EXPERT REPORT IN THE MATTER OF BIG HORN COAL COMPANY V. BROOK MINE

Prepared for Big Horn Coal Company, Sheridan, Wyoming

Prepared by Paul J. Gerlach, PG, President, Aqua Terra Consultants, Inc., Sheridan, Wyoming

March 28, 2017

C-1 Objection Exhibit A

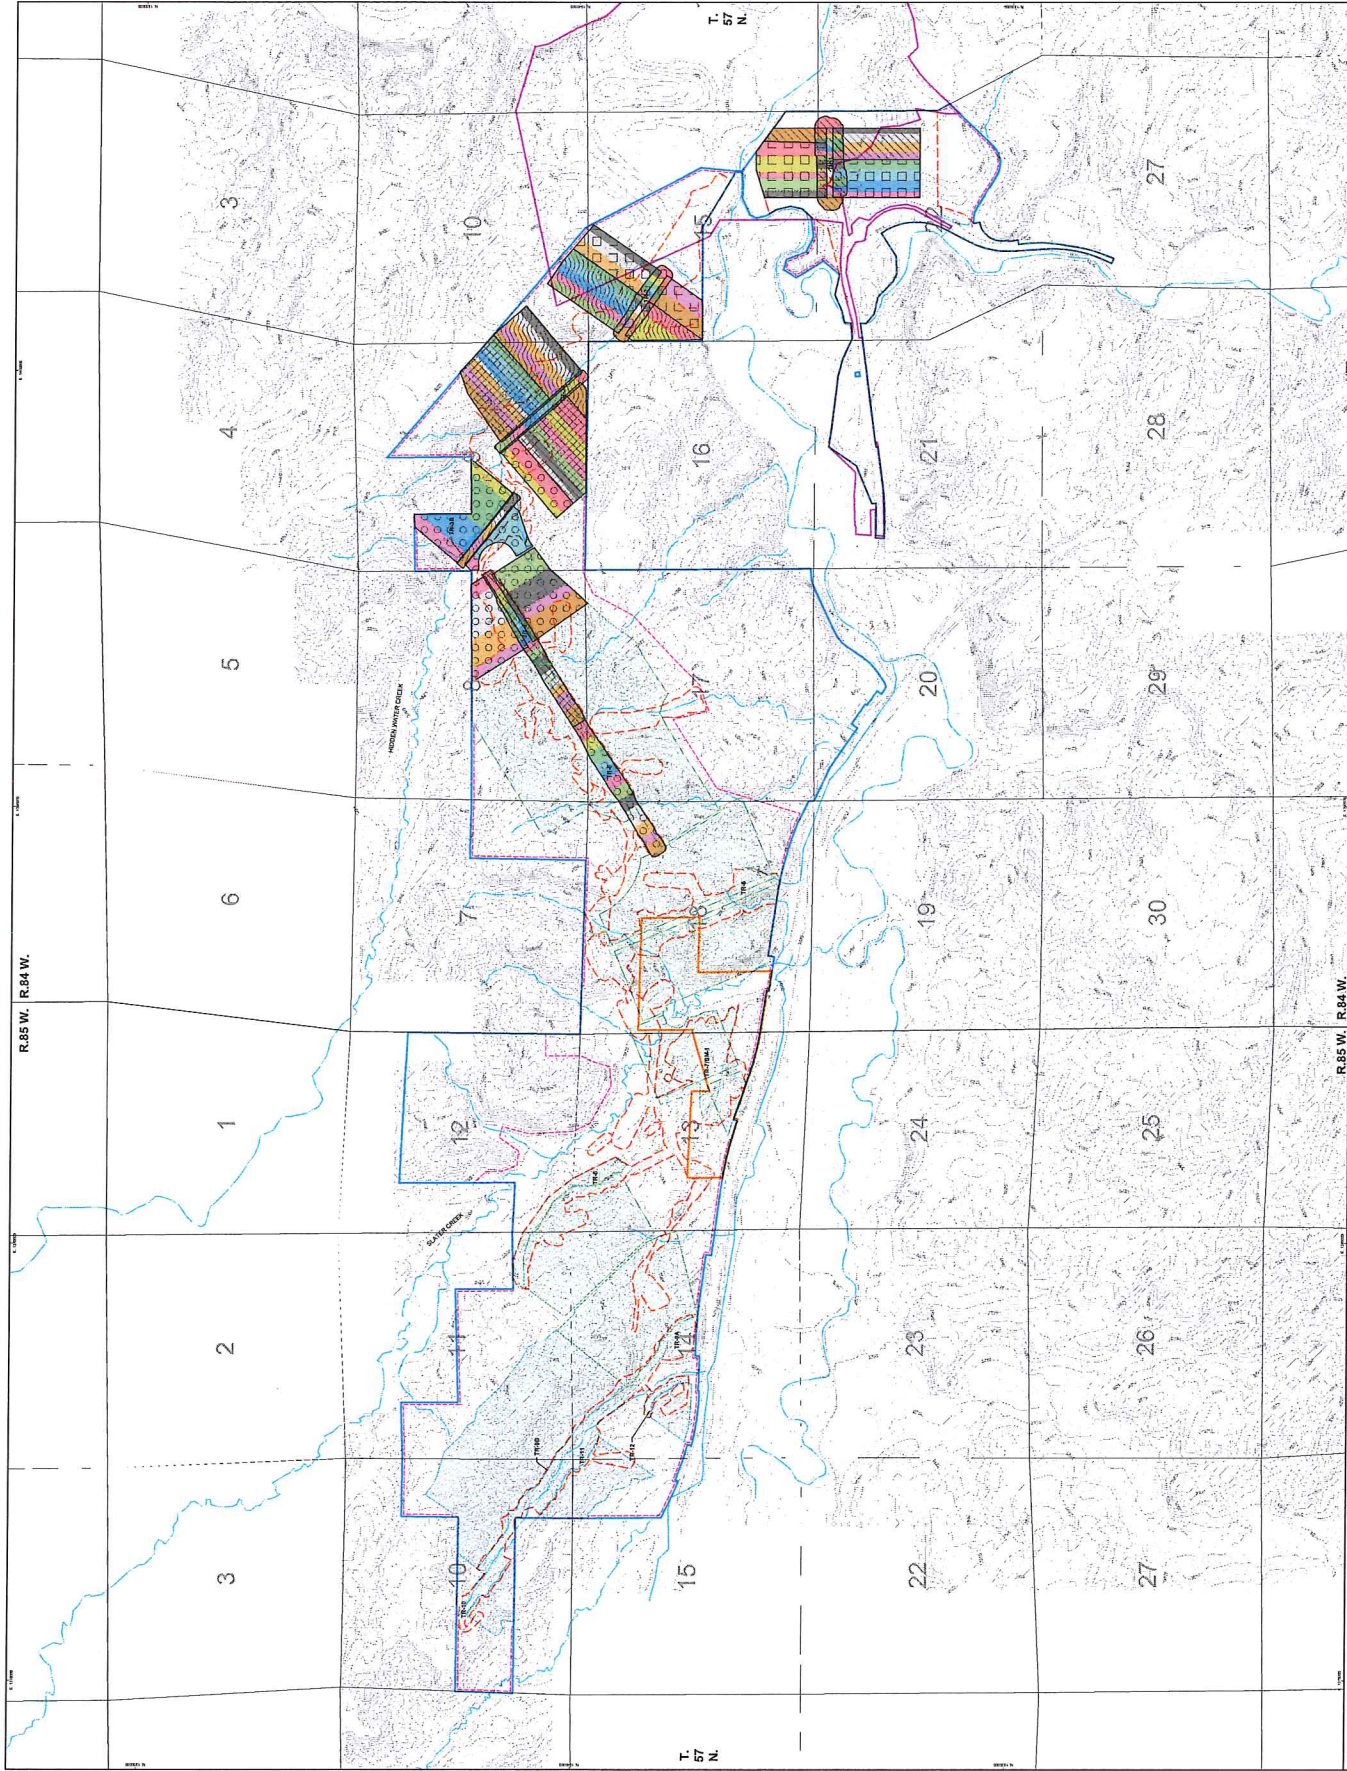
Section MP.4 and Exhibit MP.4-1 (see C1-Objection Exhibit A) provide plans for the development of a highwall mining trench through, and the development of highwall mining panels beneath, reclaimed backfill of BHCC Pits 1 and 2 adjacent to Goose Creek and the Tongue River in the southeastern portion of the Brook Mine permit area. The trench would penetrate through the bottom of the backfill to allowing mining of Carney coal found about 70 feet beneath the backfill. The backfill of the proposed trench area averages about 90 feet thick. The northeast corner of the highwall panel area appears on Exhibit MP.4-1 to be equivalent to the Brook Mine permit boundary, and would be less than 100 feet from the bank of the Tongue River. On Figure MP-6.1-1 of Addendum MP-6-11 (see C1-Objection Exhibit B), the highwall mining panels are shown even nearer to the Tongue River channel, and the reason for the disparity between the figure and Exhibit MP.4-1 is unexplained. There are off-site impact risks associated with the permit's disturbance, affected and permit boundaries all being equivalent to the mining panel boundary in this most environmentally sensitive area adjacent to the bank of the Tongue River. The affected area boundary shown on Exhibit MP.4-1 around the other proposed mining panels typically extends well beyond the disturbance boundary for reasons unexplained in the Mine Plan.

C-1 Objection Exhibit B

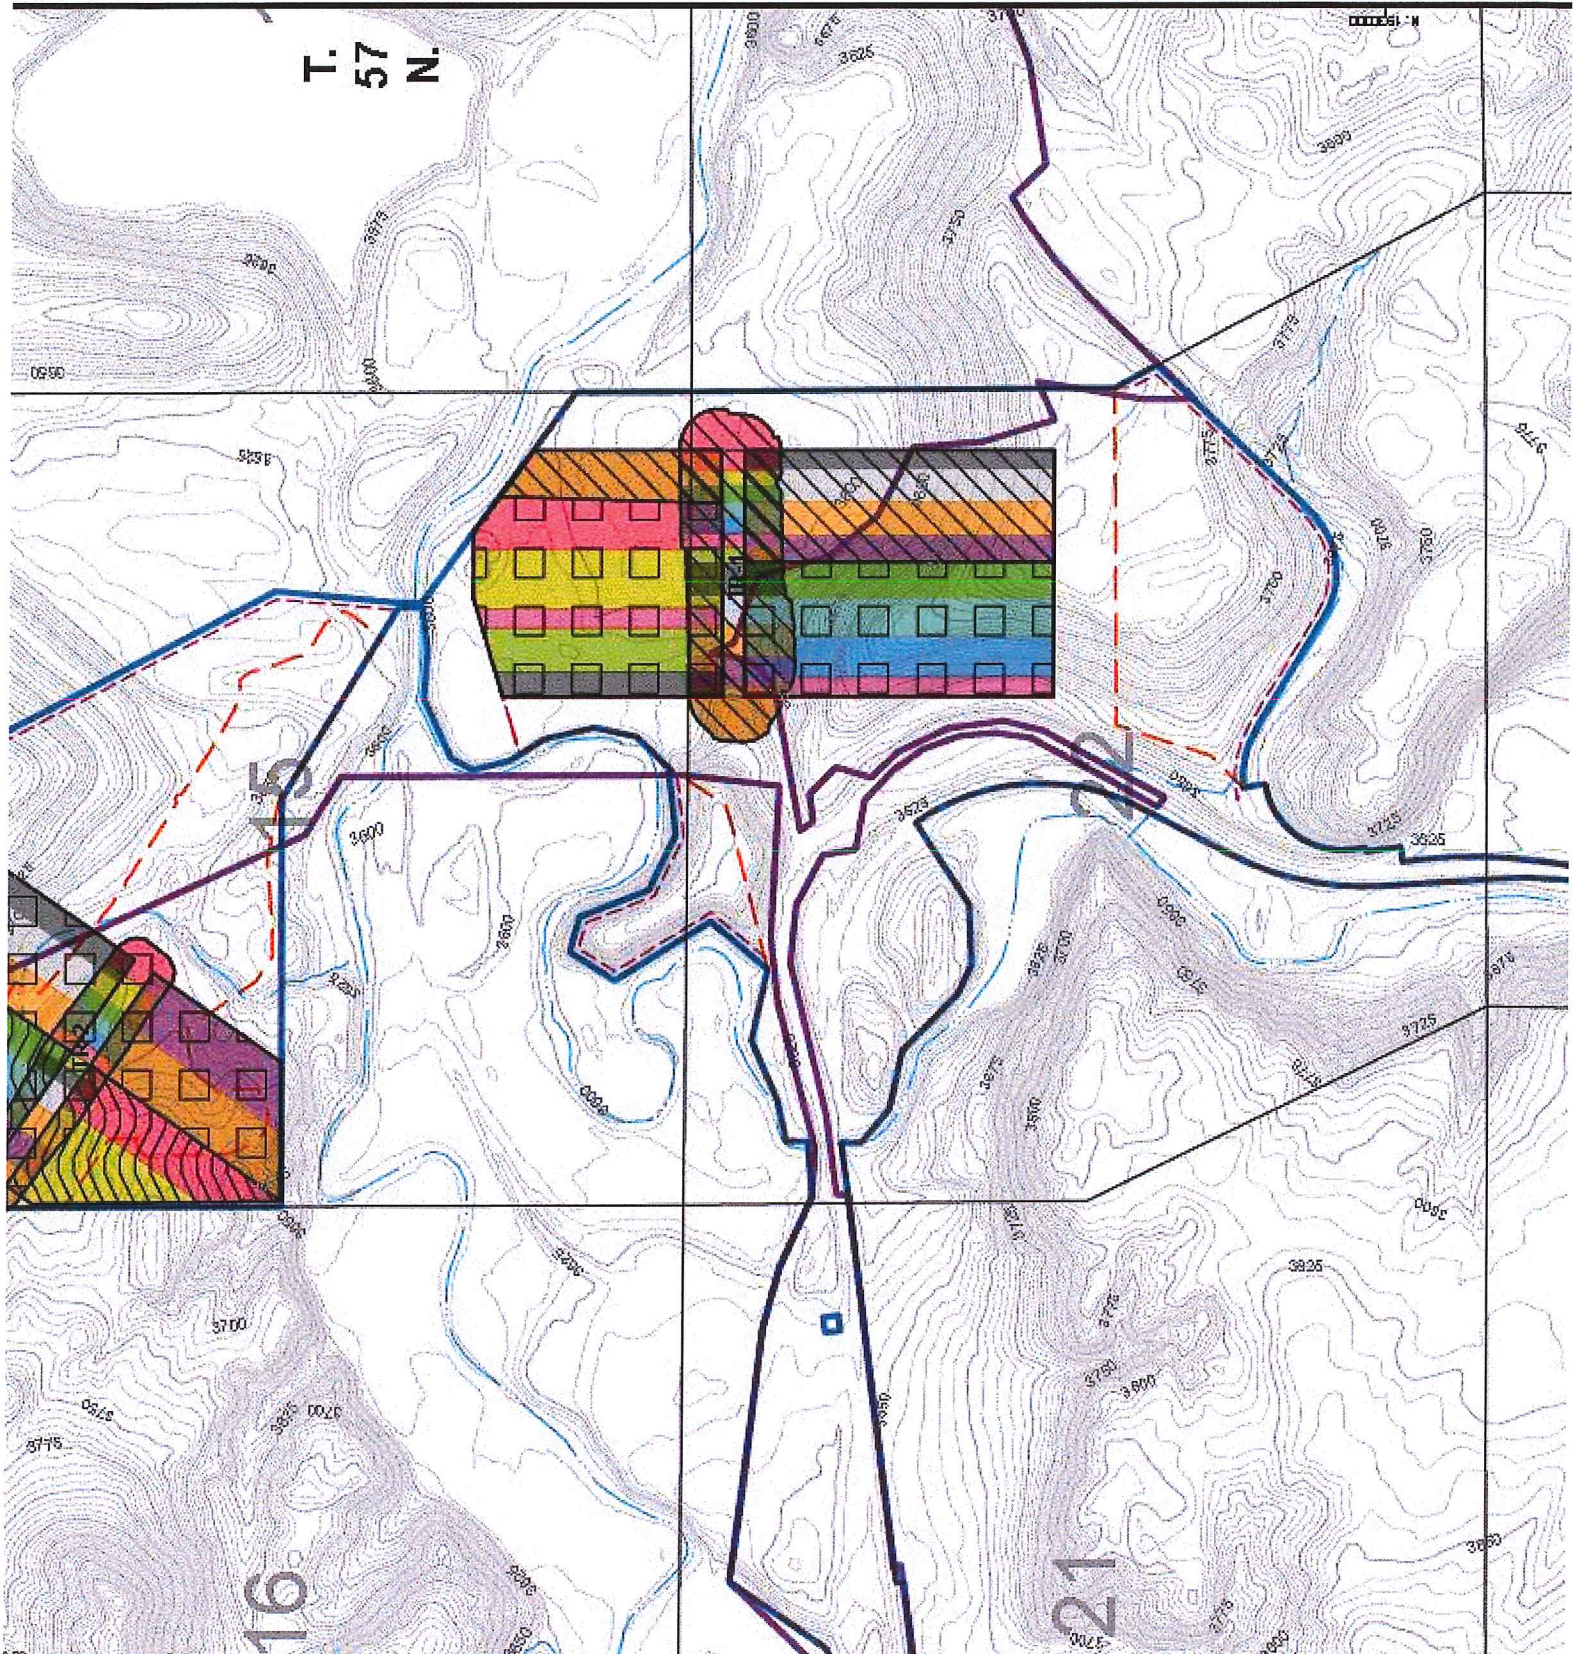
C1-Objection Exhibit B: *Figure MP-6.1-1 Showing Brook Mine Proposed Trenches and Highwall Mining Panels* (original material from Brook Mine application).

C-1 Objection Exhibit C

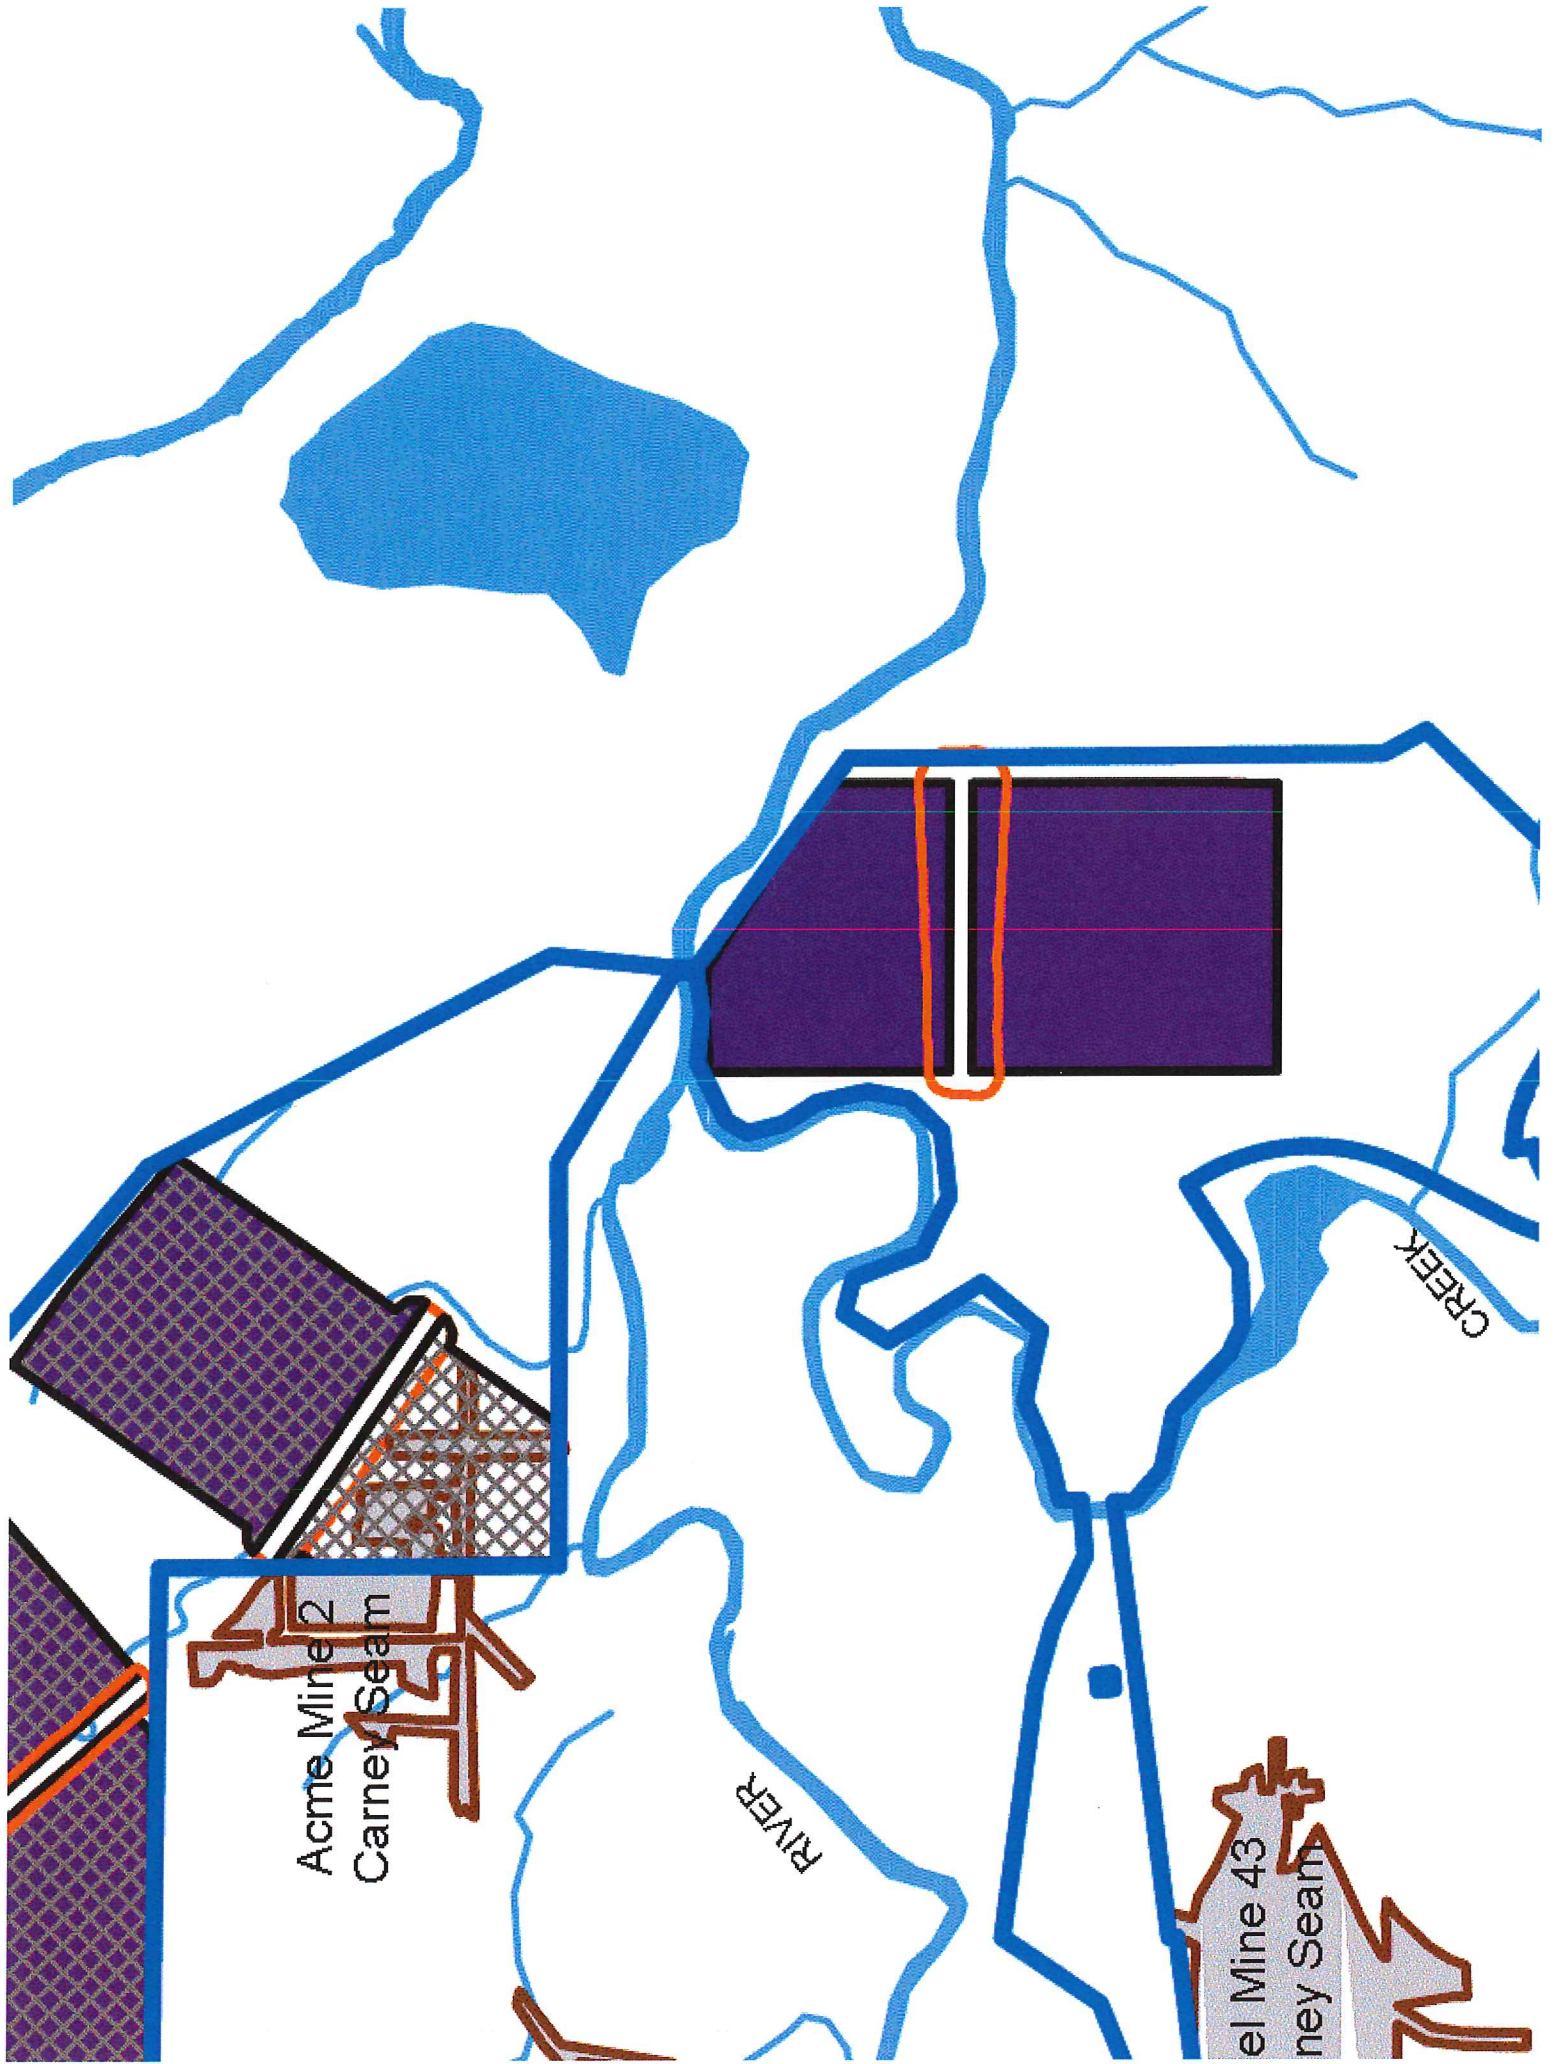
C1-Objection Exhibit C: This drawing has no formal title and is a collection of materials copied from the Brook Mine application (location of geologic cross section K-K' and locations of Brook Mine panels), and materials copied from the Big Horn Coal Mine application (location of geologic cross section D-D', area of reclaimed Big Horn Coal Mine backfill, and area of shallow water table conditions within Brook Mine TR-1 mining area).

Figure 4.9-11. Domestic Well and Alluvial Target Locations.

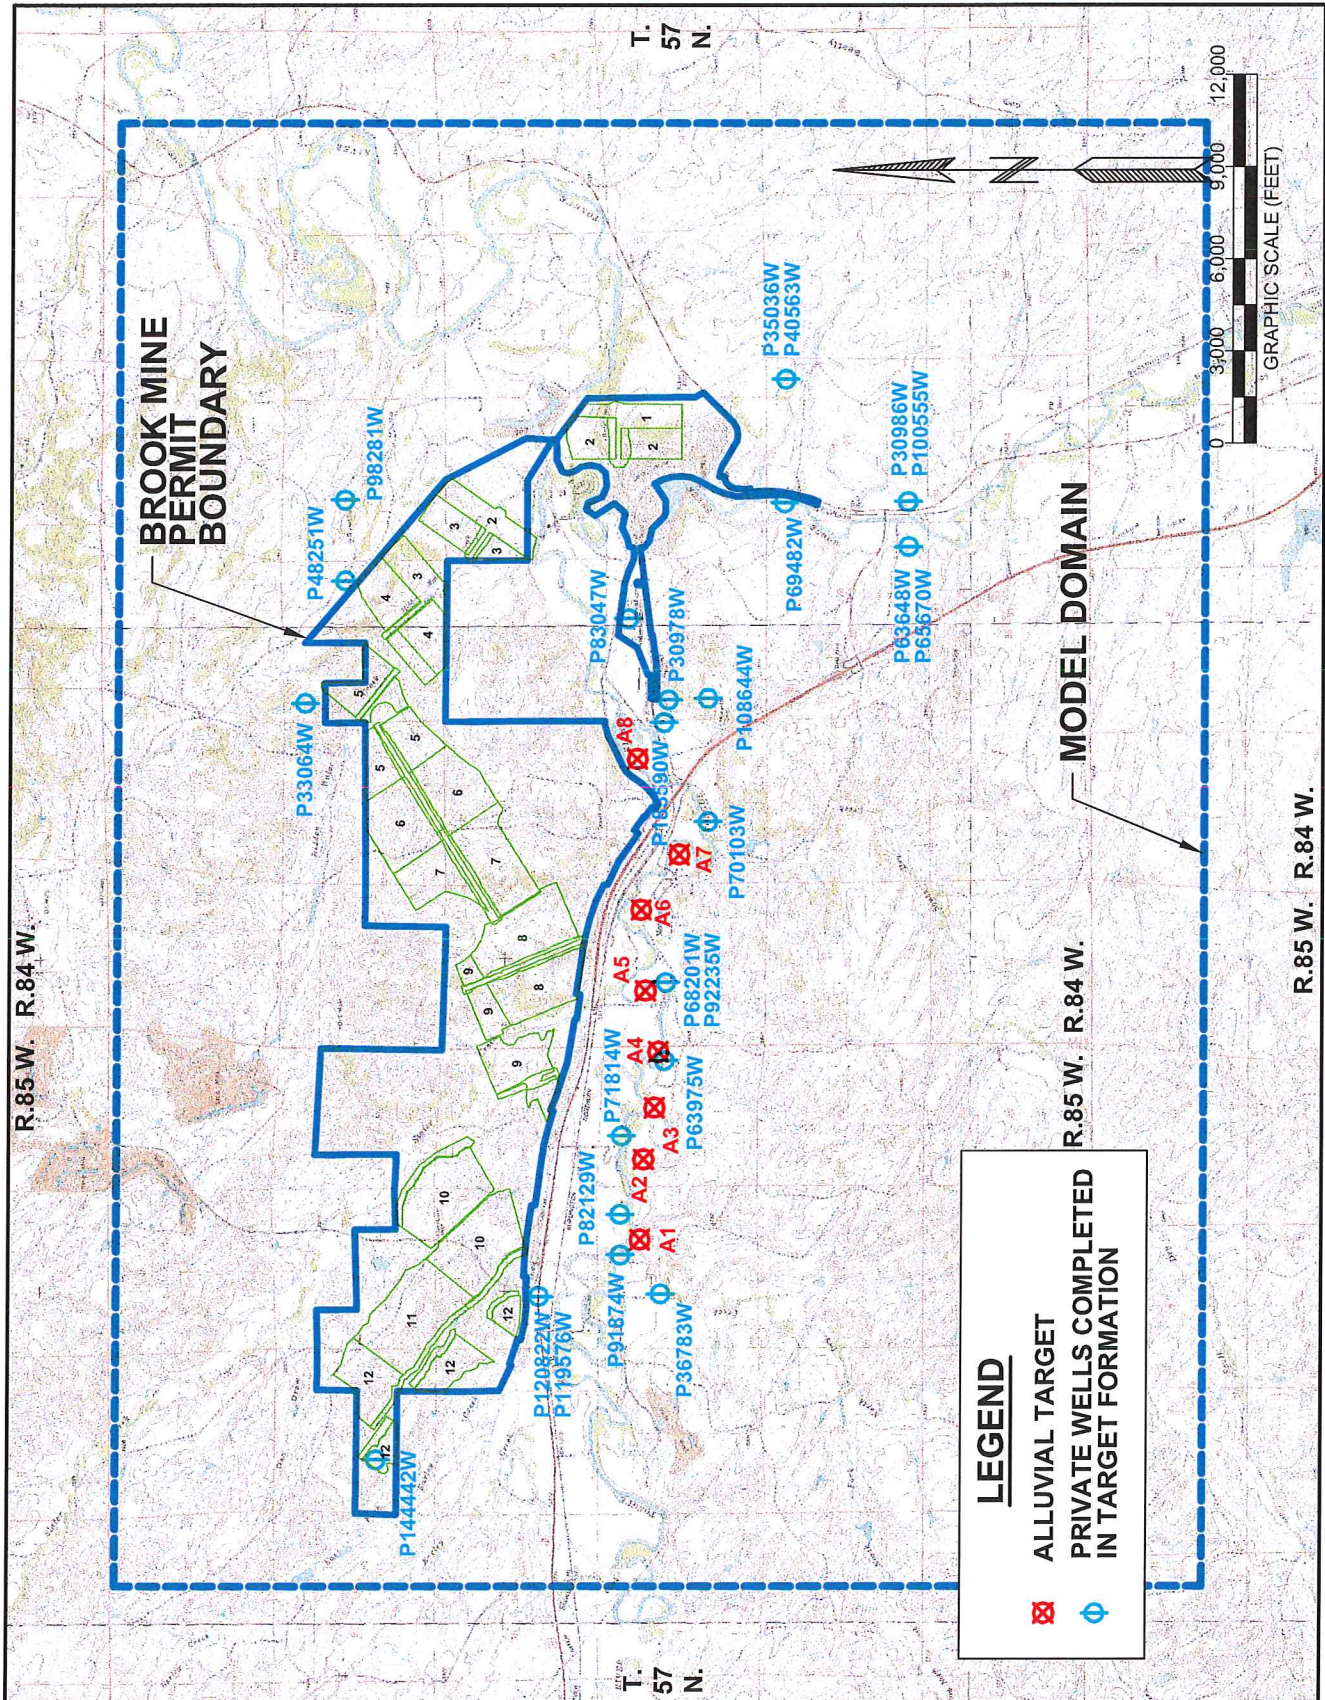
Section 4.9 and Figure 4.9-11 of Addendum MP-3 (see C2-Objection Exhibit A) shows where the groundwater model was used to predict water table drawdown in Tongue River valley alluvium at "alluvial target" points distributed over about a three-mile reach of the valley floor. Section 4.9 states that "the actual drawdown in the alluvial targets induced from mining is estimated to be less than 0.5 feet". The same text goes on to explain "maximum impacts are expected to occur in areas where the overburden is thin (near coal seam outcrops) and are of short duration". Clearly, the groundwater model causes drawdown in Tongue River alluvium only as a result of the model simulating drawdown in the upper Carney coal through Masters coal stratigraphic sequence, and not as a result of excavating through BHCC's reclaimed saturated backfill of the Pits 1 and 2 area (Brook Mine TR-1 mining area). The alluvial target points are positioned well upstream of the Brook Mine TR-1 mining area, and thereby avoid showing alluvial water table drawdown in the TR-1 area especially if the model were properly executed to include mining of the saturated backfill in BHCC's Pits 1 and Pits 2. Neither does the groundwater model explore potential permanent groundwater elevation changes associated with the highwall mining panels acting as collector drains to the backfill and alluvial water table via the backfilled highwall trench pits.

Table 4.9-1 of the Brook Mine groundwater model (Addendum MP-3) identifies maximum drawdown values predicted by the model at existing stock and domestic wells. Well locations are shown on Figure 4.9.11 (see C2-Objection Exhibit A).
